VILLAGE OF MONROE

Workshop
August 10, 2026

Village of Monroe Planning Board Review

Project: St. Rt 17M Project Supply (Gravel Lot)
Tax Lot No. 214-1-56.22
Reviewed by: David Higgins
Date of Review: August 5, 2026

Site Access

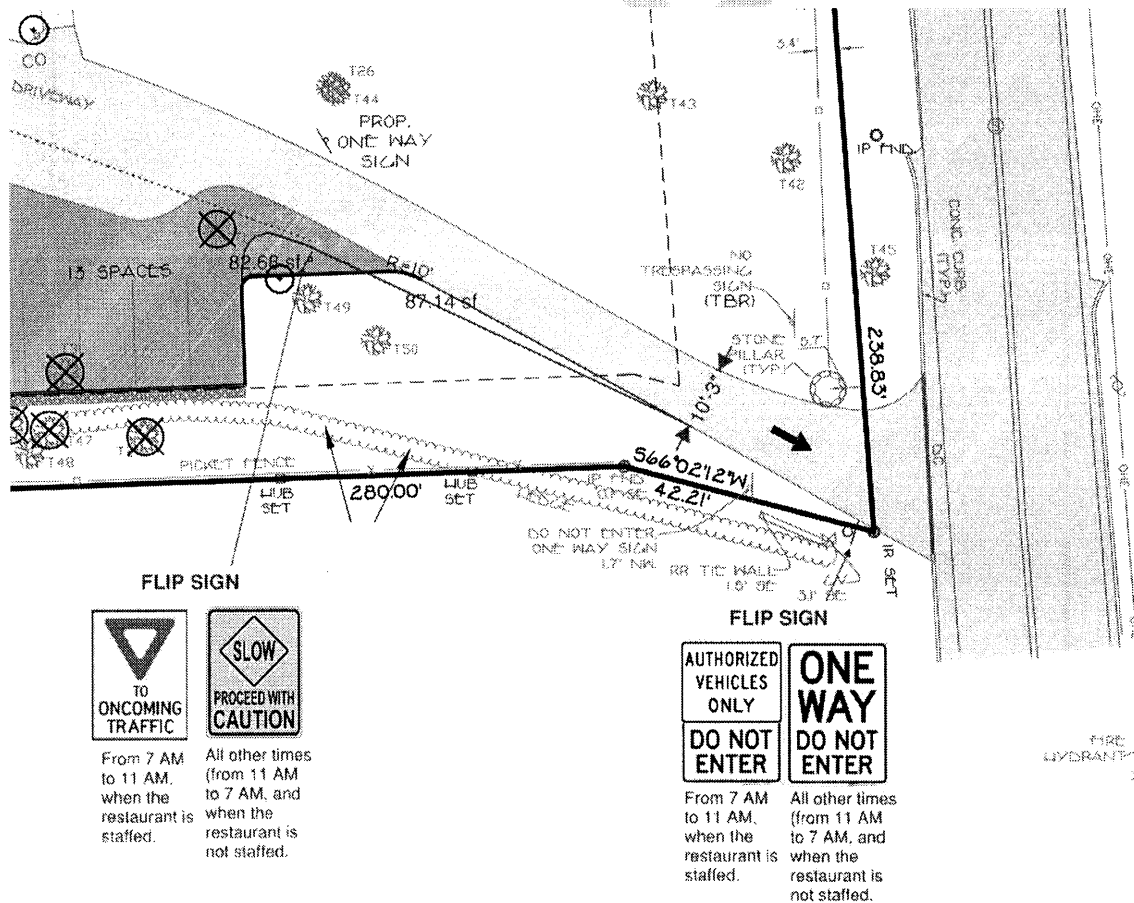
Ingress to the facility will be provided from an existing driveway at the north end of the property on High Street. This entrance driveway passes under an existing car port, which is historic, cannot be changed and has a clearance of 9 feet. Egress to High Street will be provided via an existing driveway at the south end of the property. Because of the limited clearance over the car port, it will be necessary for all trucks visiting the site to enter and exit via the south driveway and, because of the driveway's configuration, to arrive at the site from the south on High Street, turning left in, and to depart the site to the south, turning right out. The south driveway is only 110.25-feet wide where it passes to the south of a historic gateway pillar which cannot be moved or modified.

For the south driveway to safely accommodate project traffic, it will be necessary to limit incoming traffic at the south driveway to periods when there is little or not exiting traffic at the Site and to advise any motorist who might happen to be exiting when a vehicle might be entering of the need to yield right of way. It is proposed to accommodate this by installing two Flip Signs at either end of the driveway (and by widening the driveway slightly to better accommodate arriving and departing vehicles as indicated below. Both flip signs would have the ability to be locked in one of two positions, as described below.

The Flip Sign posted at the lower end of the south drive would face entering traffic and rest with the message "ONE WAY, DO NOT ENTER". This would prohibit all but emergency vehicles (with lights and sirens activated) from entering the driveway for all but a limited time period. Trucks servicing the facility (food, beverages, trash removal, etc.) would be prohibited from visiting the facility except during very specific times when the restaurant was closed and there was very little traffic activity at the site.

Day 90

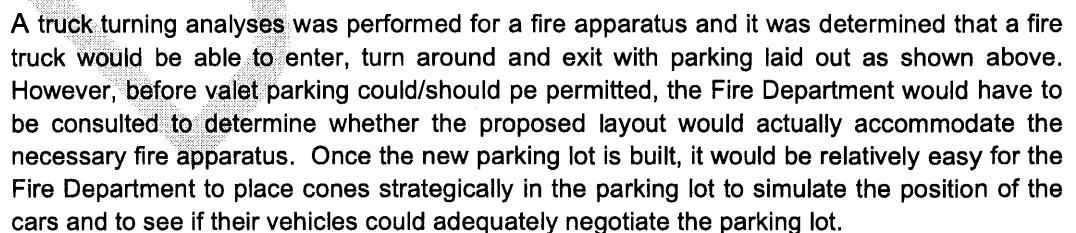
5. In addition, three-months after opening, the Planning Board may also consider whether the Applicant could employ valet parking at peak times to increase the number of vehicles that can be parked on the property. Based on a review of the Site Plan, as shown below, it is believed that a professional valet operator would be able to increase the number of vehicles parked on the site from 54/56 to 74. This would potentially allow the number of seats to be increased to 150 for an average-performing restaurant or to 113 for a successful restaurant.
